Burlington Development Review Board

Development Review Board

Tuesday, June 3, 2025, 5:00 PM

To: Development Review Board
From: Mary O'Neil, AICP, Principal Planner
Date: ~~May 6, 2025~~; Rescheduled for June 3, 2025
RE: 24 Grant Street: ZP-25-92

SHEET:
SP

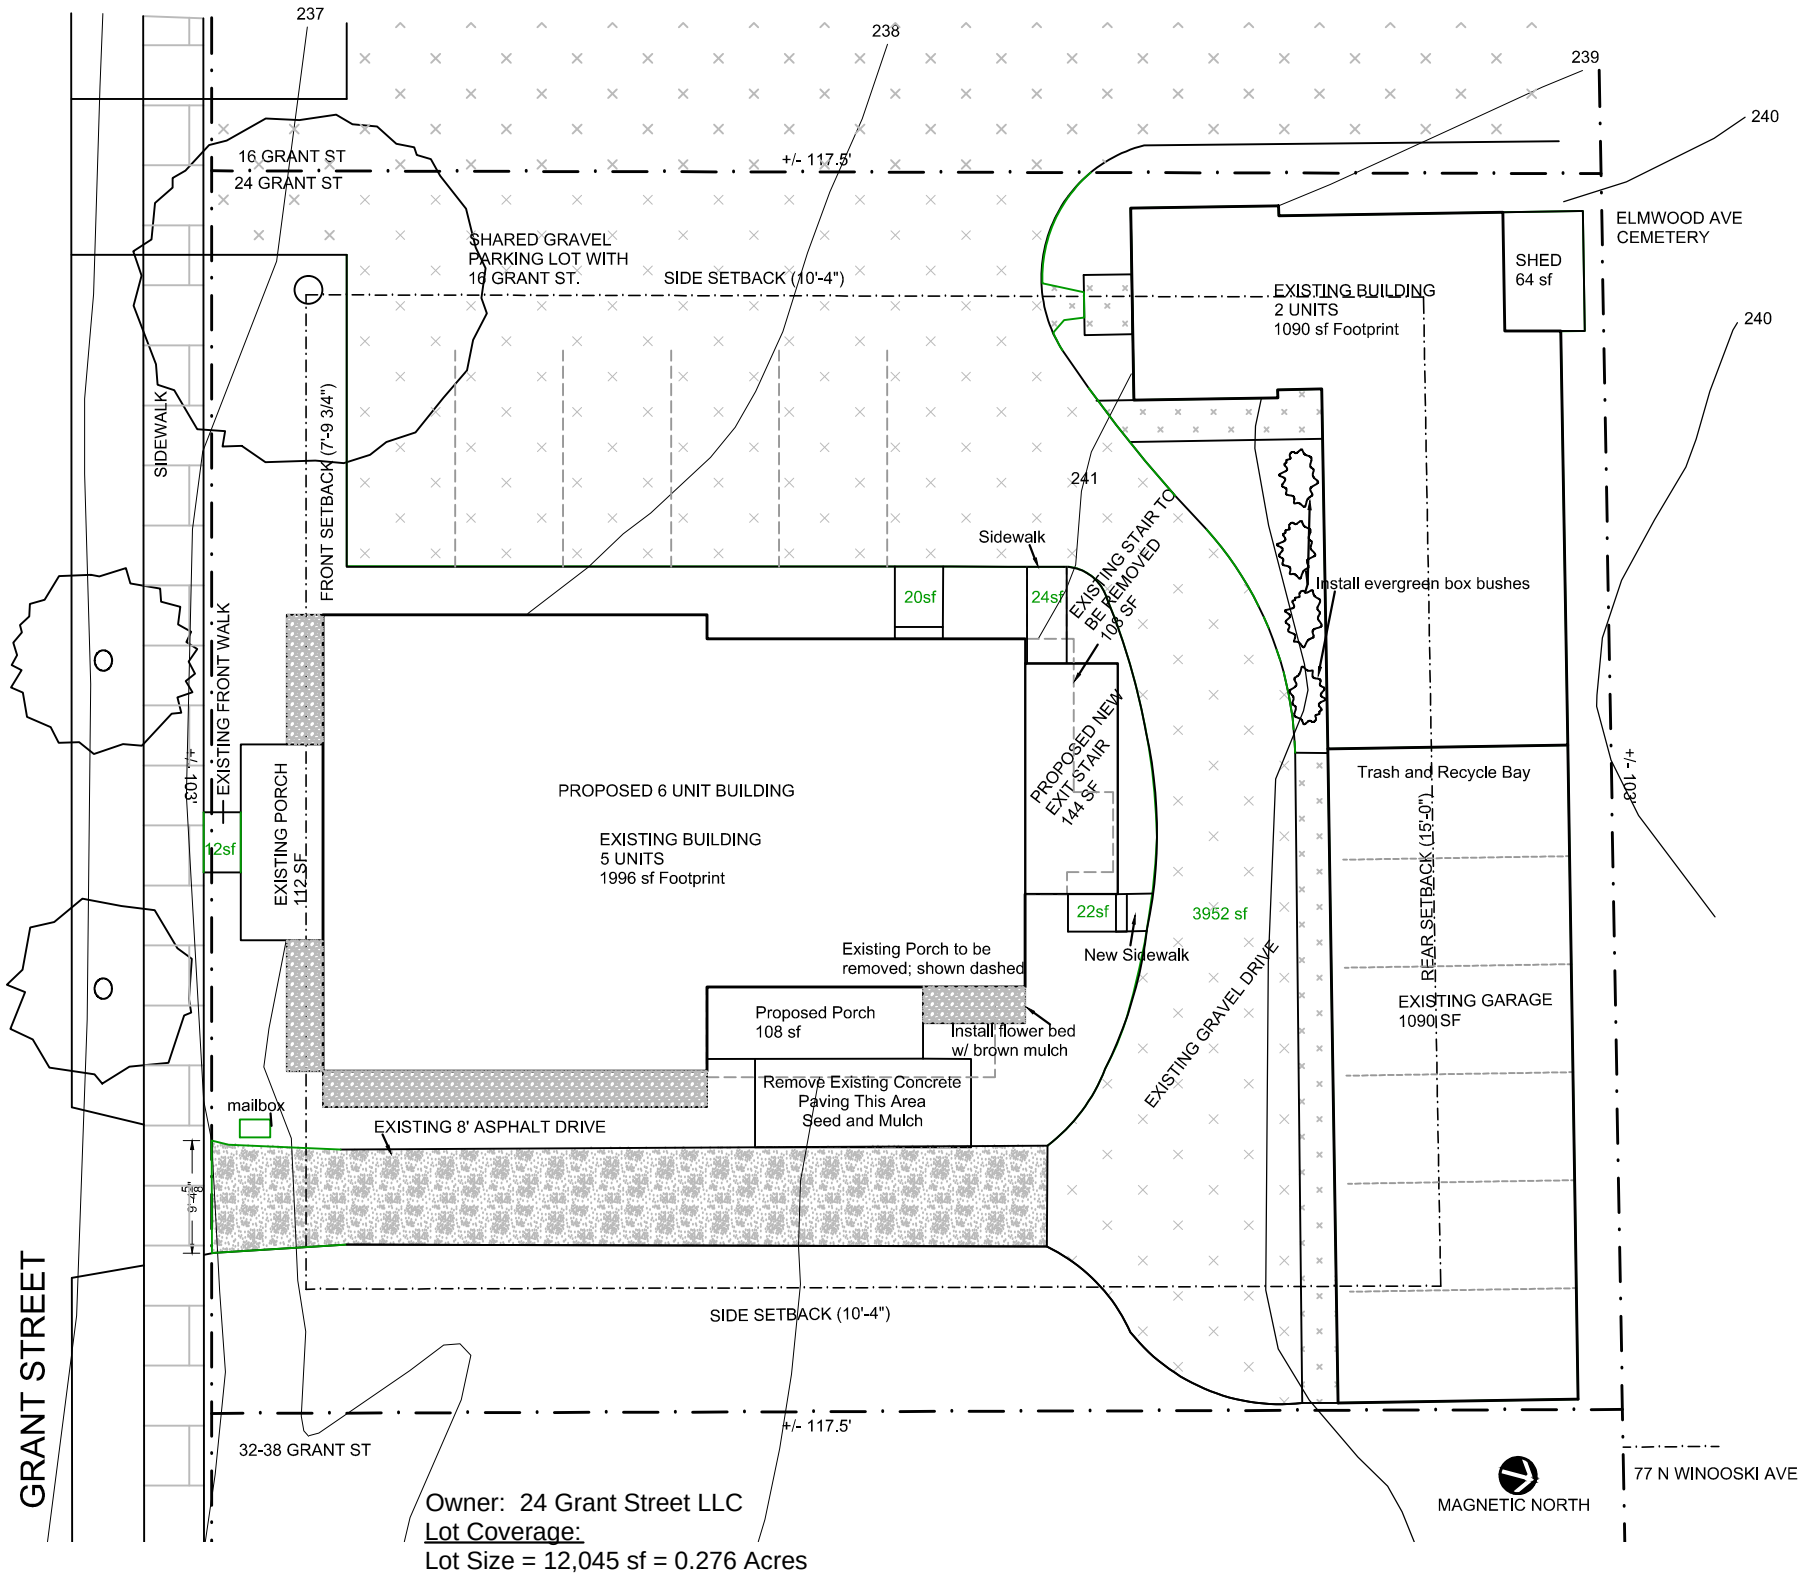
The approved 1983/1983 site plans illustrate two curb cuts, each leading to parking areas/garage. The proposed site plan modifies the 1983 plan by connecting the two vehicular areas. The east driveway is well defined, but the westerly access has created the equivalent of a shared driveway with 16 Grant Street. **Affirmative finding.**

The site plan has functionally changed in that the two access drives (east, west) have been connected in a gravel lane between the buildings; eliminating the 2 parking spaces in front of the garage, and expanding the gravel onto the 16 Grant Street parcel. Parking minimums are no longer applicable and shared access driveways are allowed. **Affirmative finding.**

A2.1

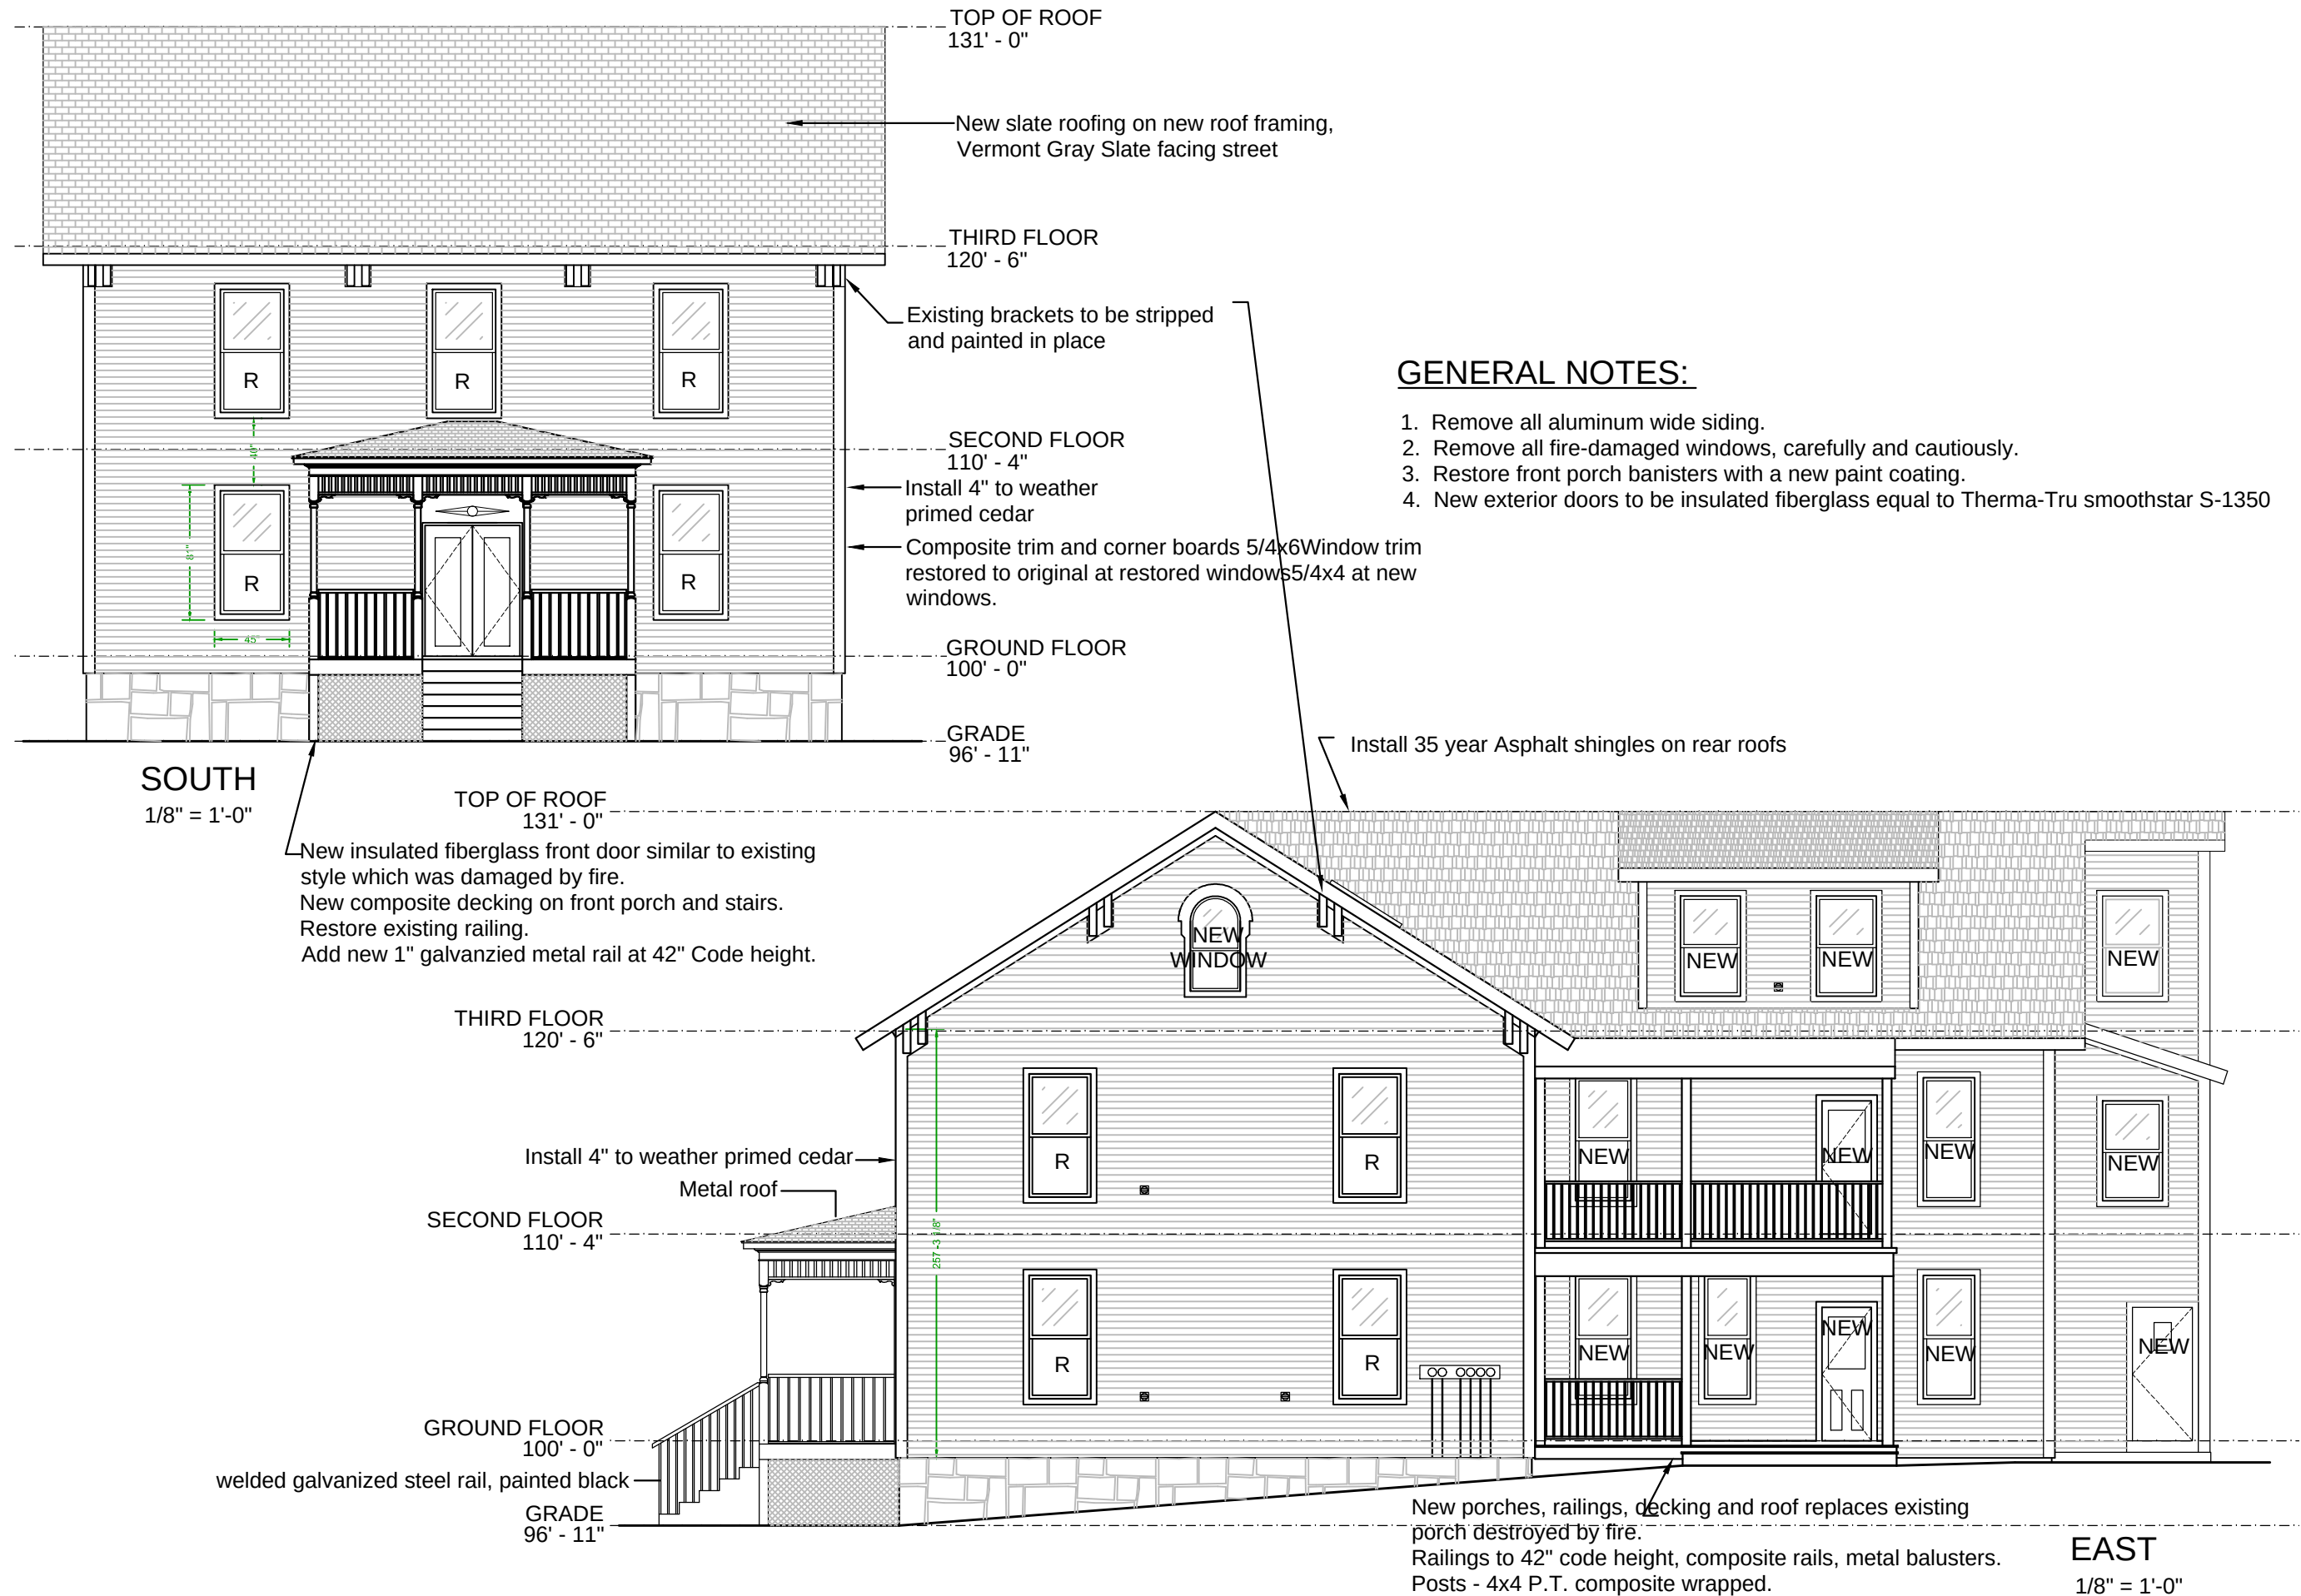
The application proposes re-installation of a Vermont Strata Gray slate roof on the primary structure, while the rear addition will have asphalt shingles. See Plans A 2.1 and A 2.2. **Affirmative finding.**

primed cedar, and the existing brackets are to be stripped and painted in place. Front porch balusters will be repainted, and a Vermont Gray slate roof will be installed on the historic main structure, with asphalt shingles on the rear (north) addition. A new fiberglass door will be installed at the Grant Street entrance. See Plan A2.1. **Affirmative finding.**
